PLANNED UNIT DEVELOPMENT (PUD) PLAN and
PRELIMINARY OVERALL AREA DEVELOPMENT PLAN (POADP) for
WEST STAR SUBDIVISION and
WEST STAR PLANNED UNIT DEVELOPMENT

Re: Weststar Subdivision

POADP # 558

The City Staff Development Review Committee has reviewed Weststar Subdivision Preliminary Overall Area Development Plan # 558. Please find enclosed a signed copy for your files. Although your plan was accepted, please note the following:

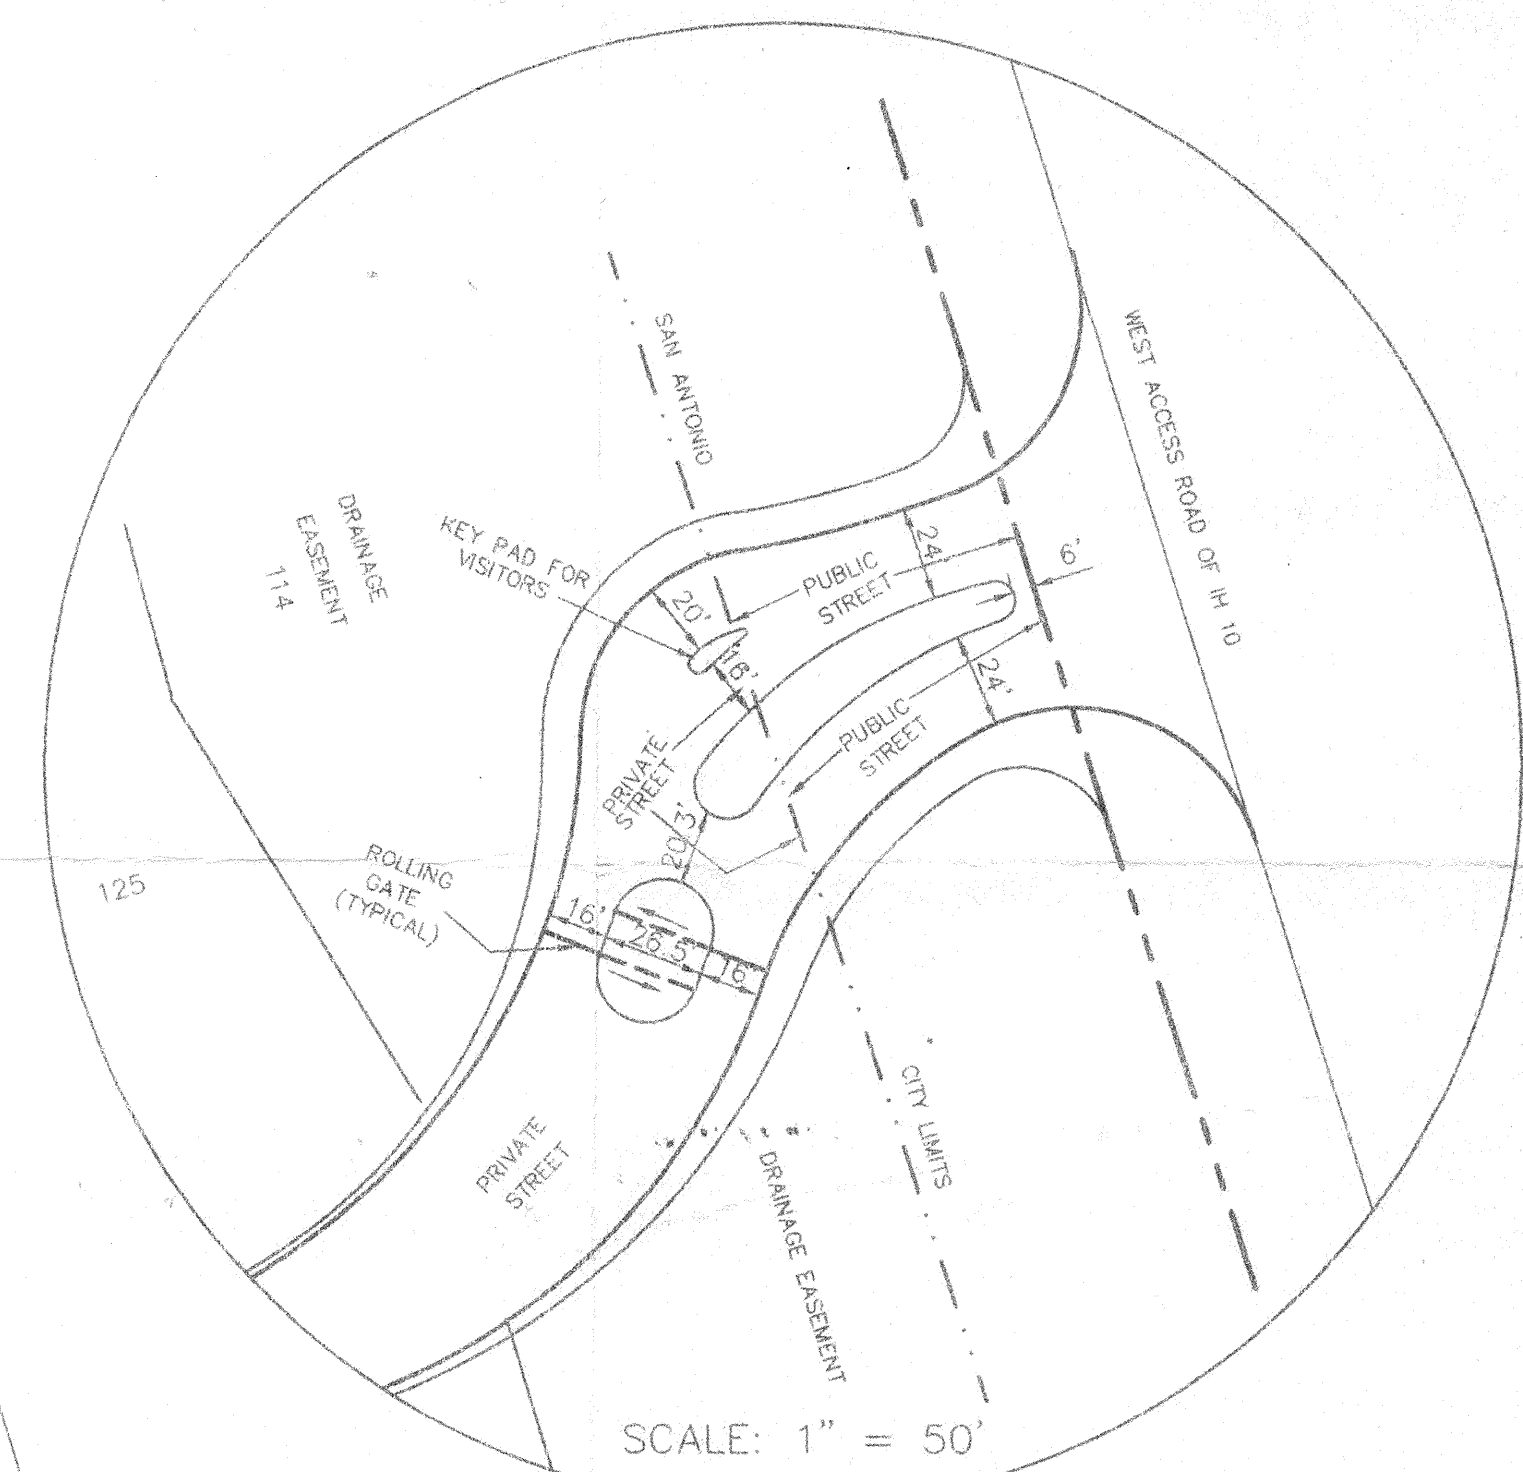
- Based on the topography, a Flood Plain Study and drainage review will probably be required during the platting process.
- If the proposed development is not platted in phases or units this POADP will not be valid.
- Access and R.O.W. issues along State facilities will need to be resolved with the Texas Department of Transportation (TXDOT). For additional information about these requirements you can contact TXDOT at 615-5814.

Flood Plain Requirements and Drainage
Ease must will be require and address
during the platting process.
